CALIFORNIA COASTAL COMMISSION

STAFF REPORT: DE NOVO HEARING

Appeal Number: A-3-SNC-14-0001

Project Description: Construct a 340-room resort complex including a 235-room standard operating hotel, a 105-room condominium hotel, two restaurants, a conference center, onsite parking, a wellness spa, on and offsite road improvements (including to Sand Dunes Drive and Tioga Avenue), public restrooms, a lifeguard station, public access and parking, and related development.

Exhibit 4 View Sims/Sections (from Hwy 1)

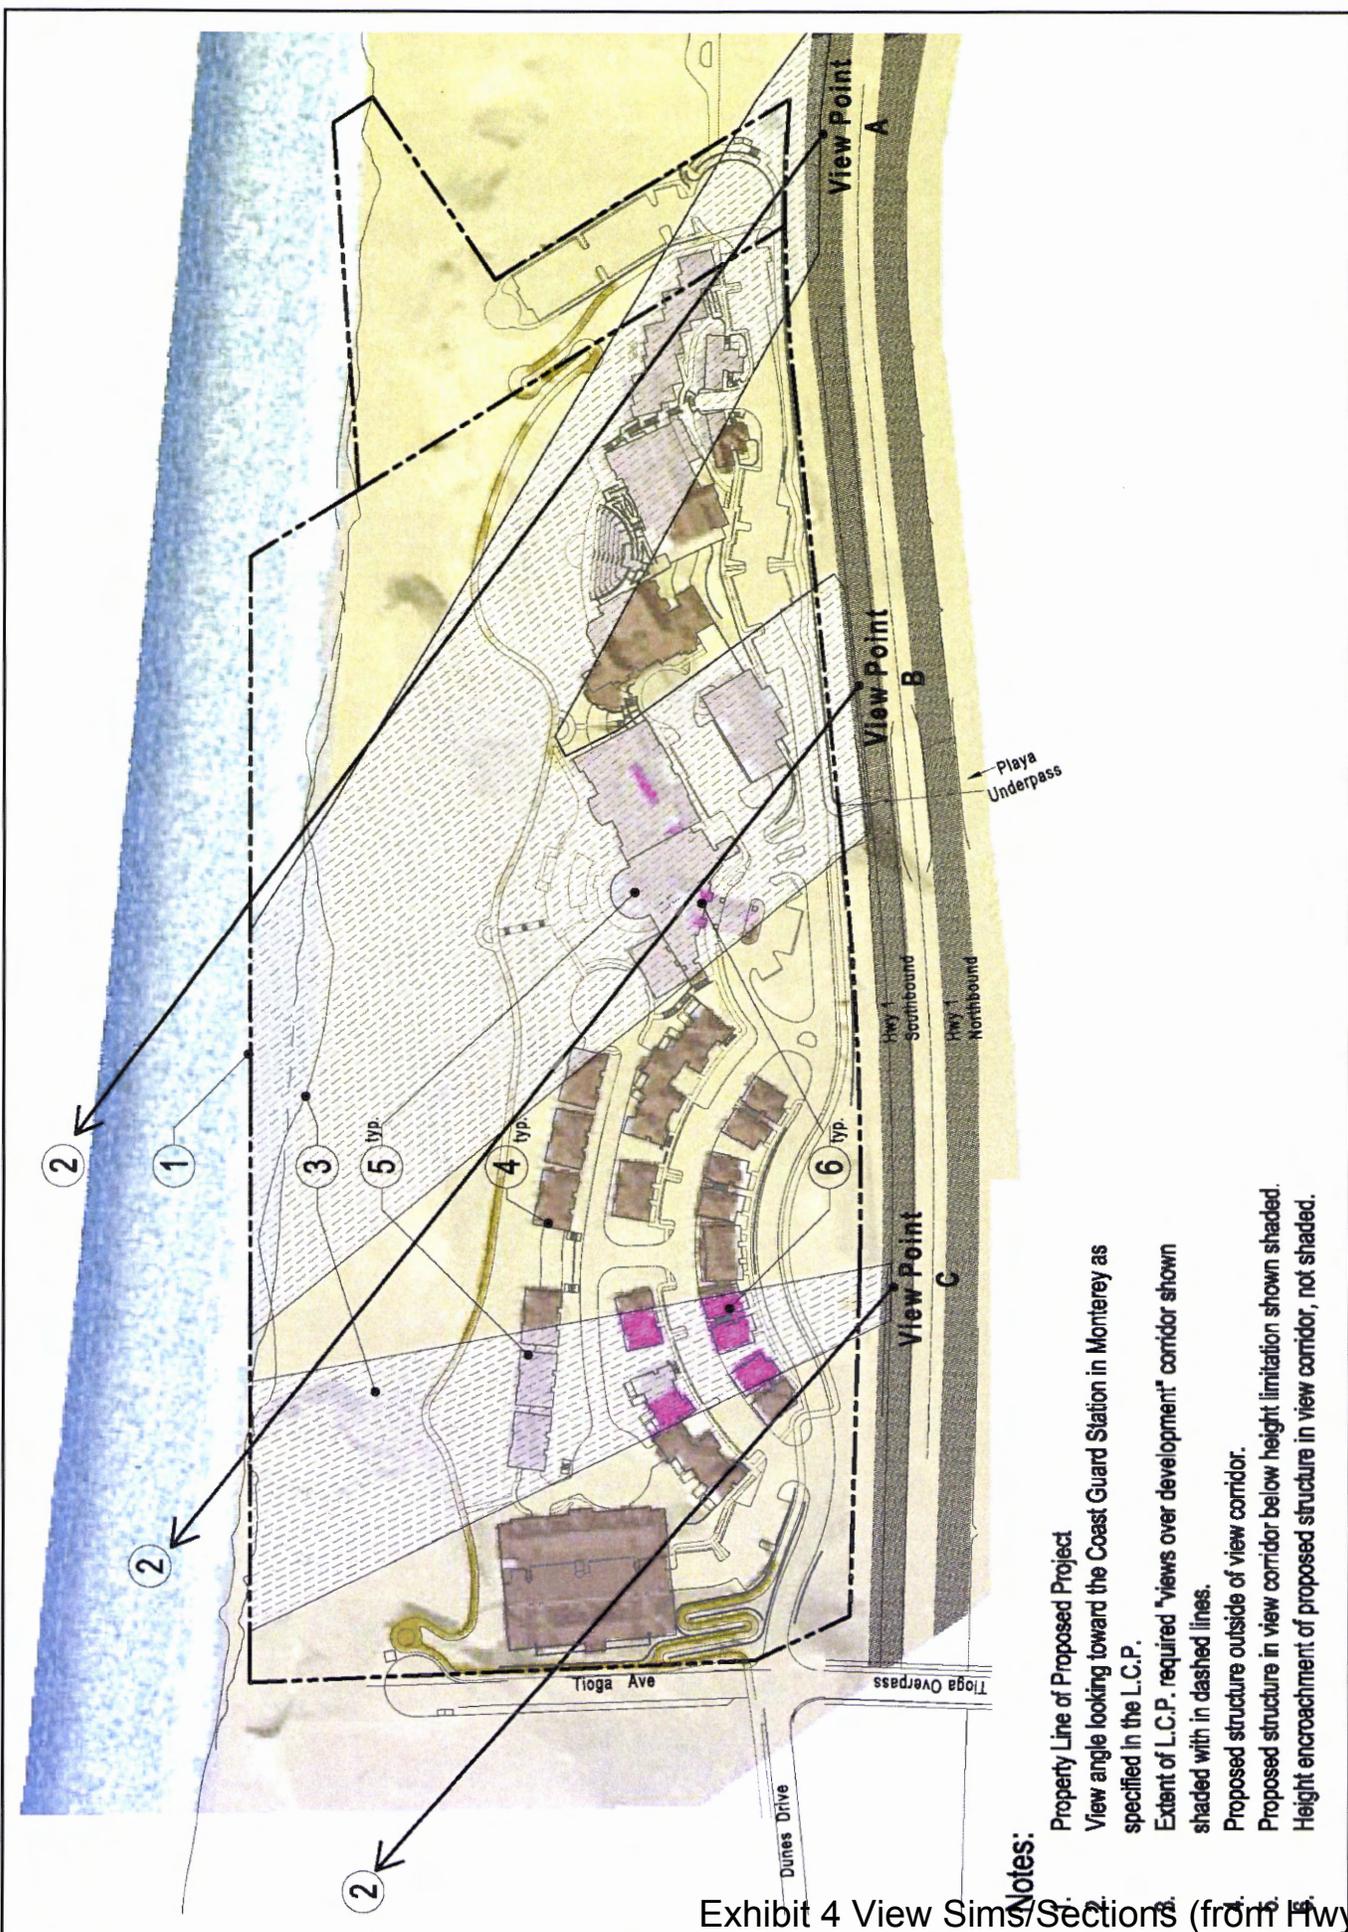
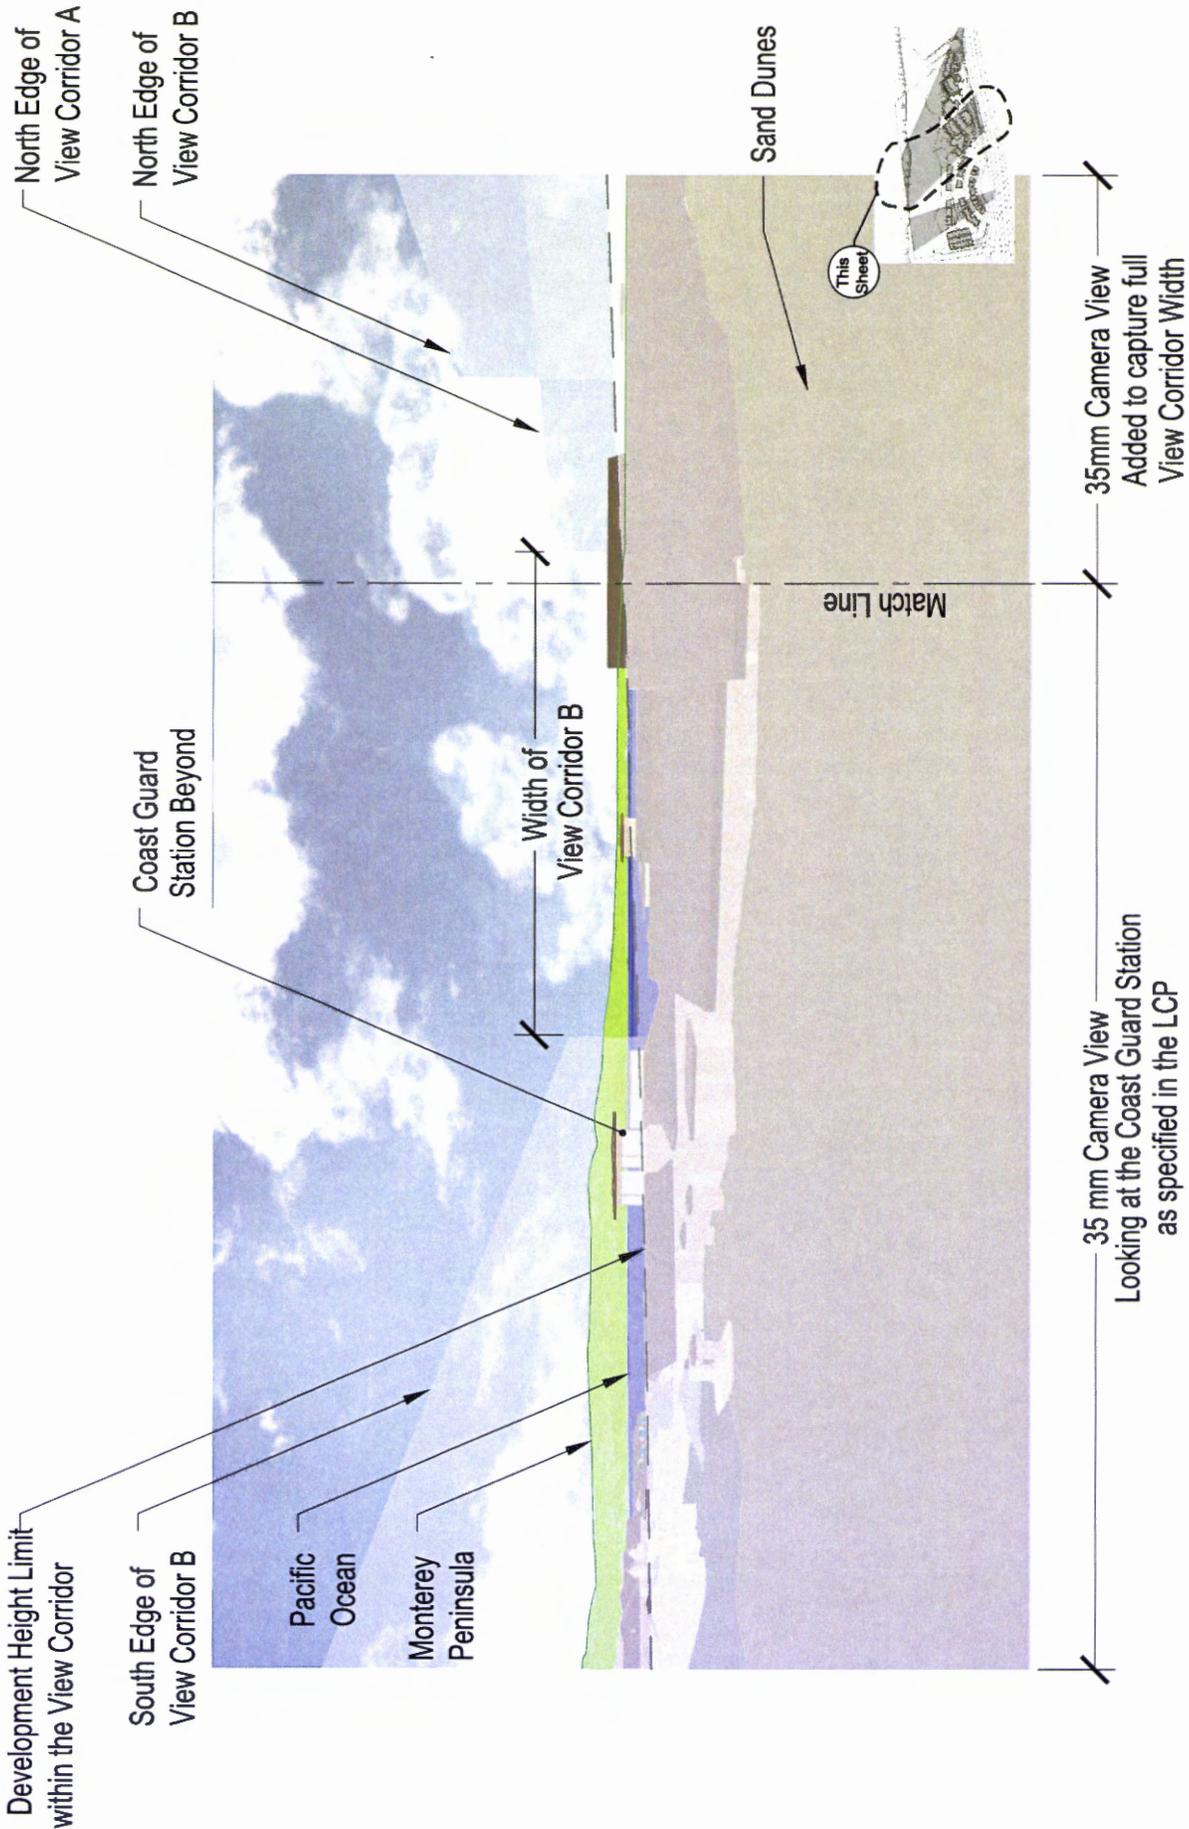
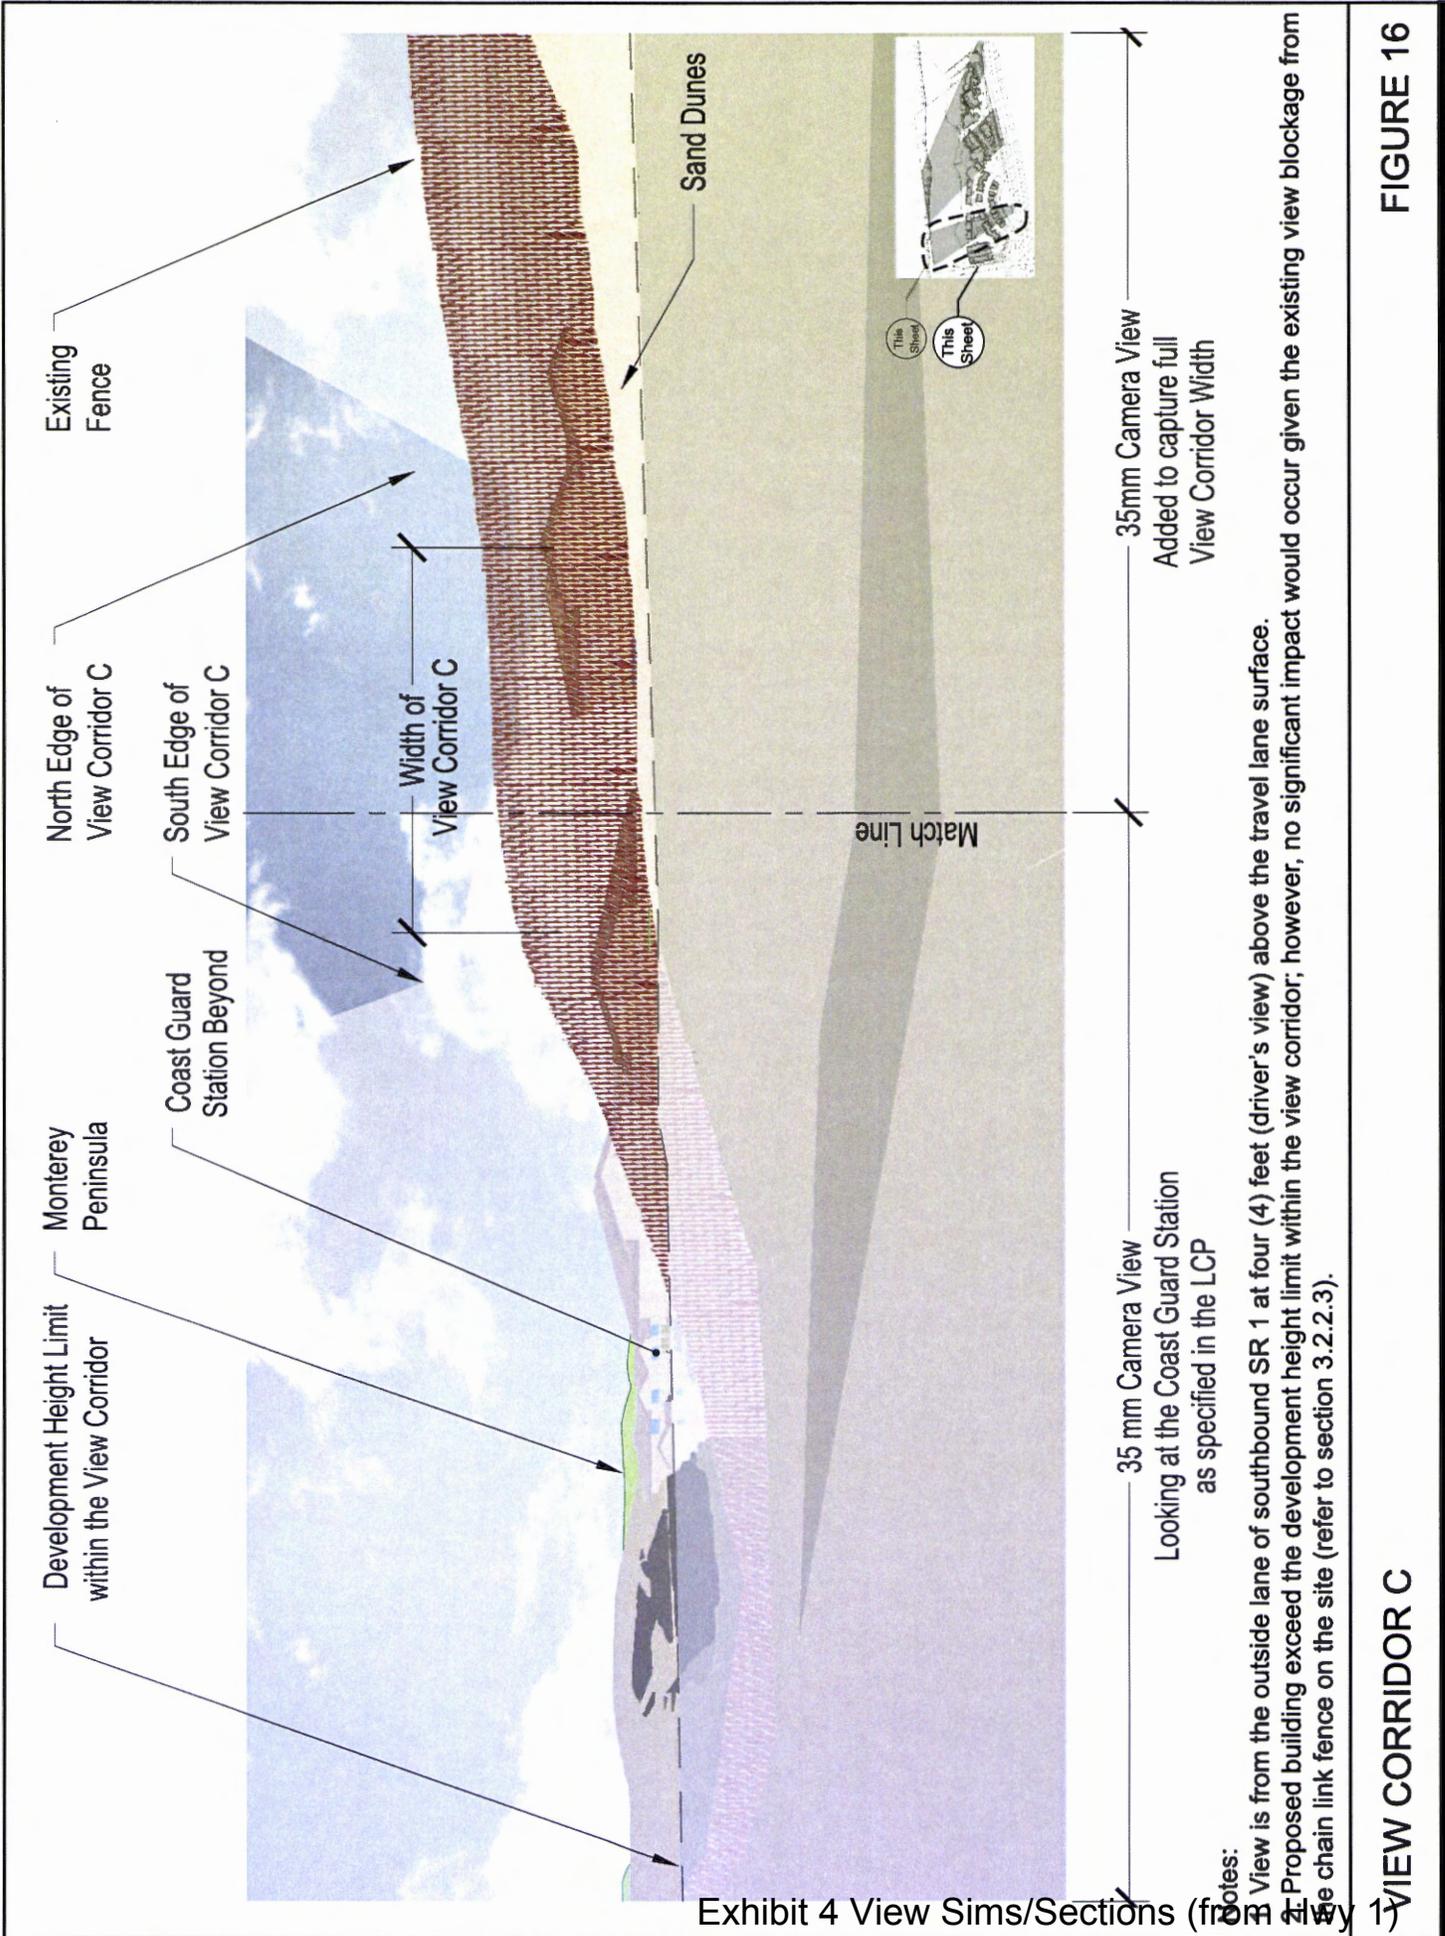
LUP Policy 5.3.3.b prohibits development that would intrude upon, or block, an unobstructed view of more than one-third of the lineal distance across the Bay as measured between the Highway One right-of-way and the landward edge of the Coast Guard Breakwater in Monterey. The Applicant provided an analysis of the project's visual impacts from each of the three view corridors shown in Figure 9, but used a different test for establishing compliance with the "one-third lineal distance" requirement than that specified in the LCP. The Applicant's analysis involves an estimate of the amount of visible development within a vertical space between the Highway One elevation and finished floor elevation for building elements as viewed above the bluff edge. The Applicant contends that if less than one-third of the "view" within that vertical space would be blocked by the proposed development, then public views would be preserved consistent with the LUP's "views over development" policy (see **Exhibit 4** for the Applicant's visual analysis). A review of the Applicant's visual analysis showed that in two of the three instances, less than one-third of the "view" within that vertical space would be blocked by the proposed development.

LUP Policies 5.2.2 and 5.3.2 require the protection and enhancement of visual access, views, and scenic areas, including via the provision of view corridors, vista points, dune restoration areas and other measures as identified in Figure 9 of the LUP. In particular, Figure 9 identifies the southbound Highway One view where the Fremont Street on-ramp merges onto the highway and the roadway bends slightly to the south as a “Key Coastal Overview.” This is the point where southbound motorists obtain the first full view of the Sand City shoreline, with Monterey Bay, and the Monterey Peninsula in the distance. The entire shoreline from Sand City all the way to Point Pinos in Pacific Grove is visible in this view. This is probably the finest coastal and
